Index 653-001 Pedestrian Control Signal Installation Details

COMMENTARY

The TERL has received multiple questions from Contractors regarding clarification of grounding requirements for pedestal poles. This update is to help clarify requirements to reduce future questions. Corresponds with Specification update to 620-3.3.

LAST REVISION 11/01/25		DESCRIPTION:	 FY 2026-27 STANDARD PLANS	PEDESTRIAN CONTROL SIGNAL INSTALLATION DETAILS	INDEX 653-001	SHEET 1 of 1

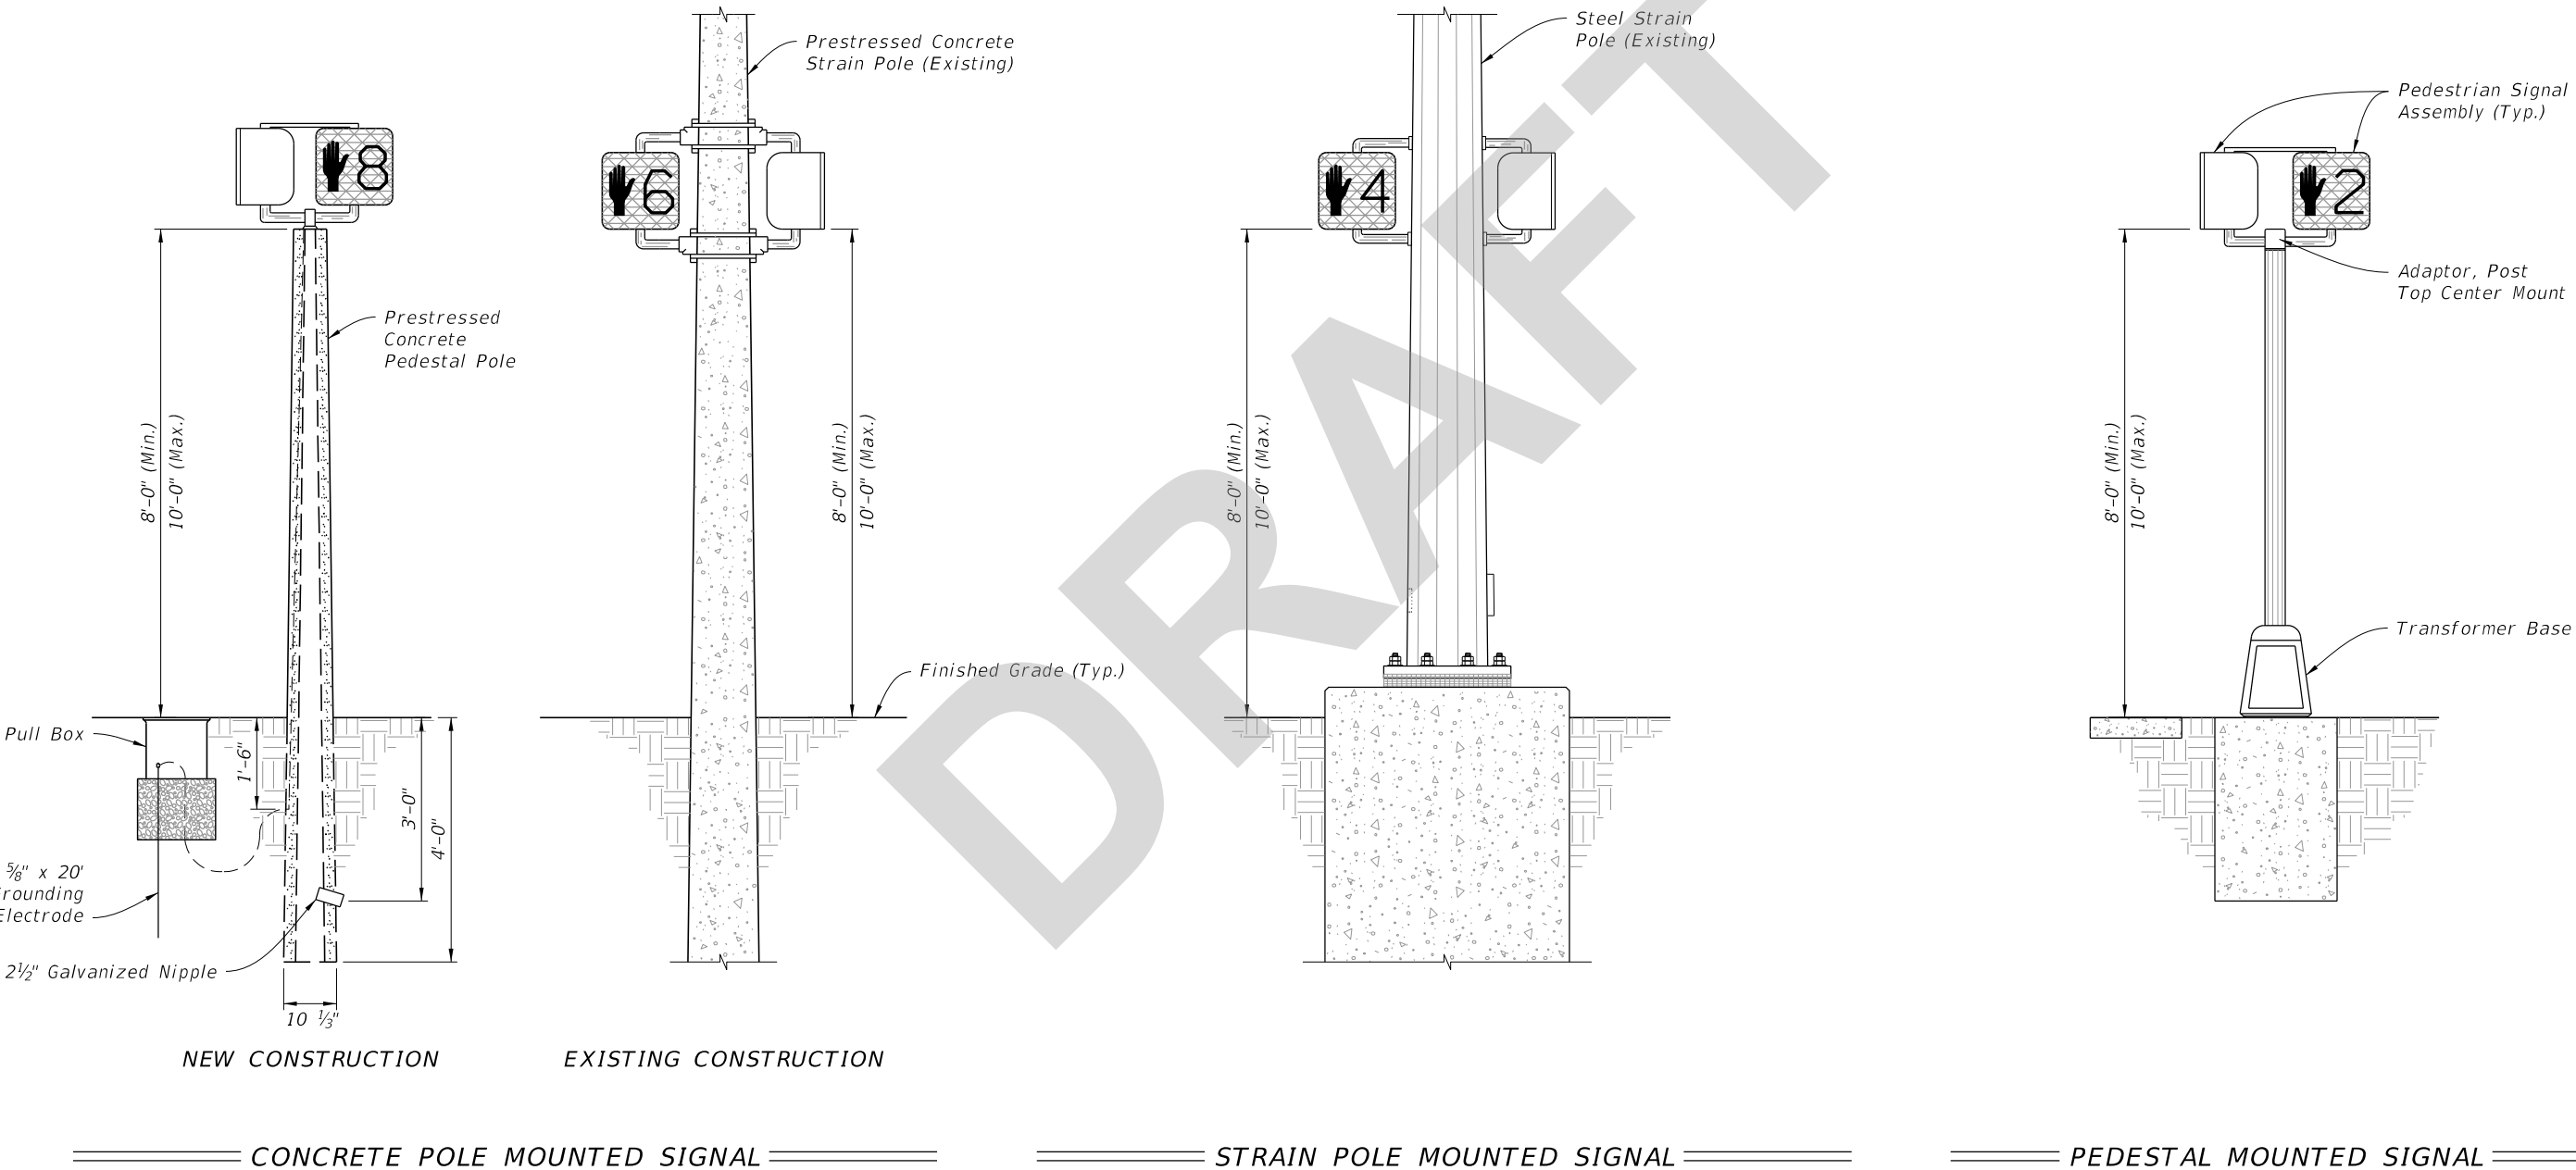
COMMENT: For the Pedestal Mounted Signal Detail, should the ground electrode conductor be shown to terminate onto a ground lug mounted on the wall of the transformer base? Also, should the ground conductor of the pedestrian signal head from the cabinet be shown to be terminated onto the ground lug? All metal components of the system, including the pole itself, will then be bonded together to create a continuous grounding network, including the grounding wire from the pole to the ground bus inside the traffic signal cabinet.

COMMENT: For the Concrete Pole Mounted Signal Detail, should the ground electrode conductor be shown embedded in the pole as shown in Index 641-010 rather than inside the pole cavity?

COMMENT: The pull box configuration for the Pedestal Mounted Signal is shown in Standard Plans Index 646-001. I would suggest not showing it in multiple places as this could cause confusion. Also, the Electrode Wiring is shown in the void of the pole in the Concrete Pole Mounted Signal. I do not believe this is the correct way to show it.

RESPONSE: The depiction in the Index is not intended to provide the details of specific connection types and locations as this may vary. However, we do recognize the potential issue and we will add a note to Index 646-001 that states: "For pedestal mounted signals, route and terminate the grounding electrode conductor to a ground lug within the transformer base". This will have to wait until next cycle as we did not make any revisions to Index 646-001 this cycle.

RESPONSE: Thank you for your comments. Yes I agree that most of the information is shown in Index 646-001. We will delete the newly proposed pull box detail. We will revise General Note 7 to ensure the users know to look in Index 646-001. We will also revise the Electrode Wiring in the pole.

CHANGE MADE TO INDEX: Yes.
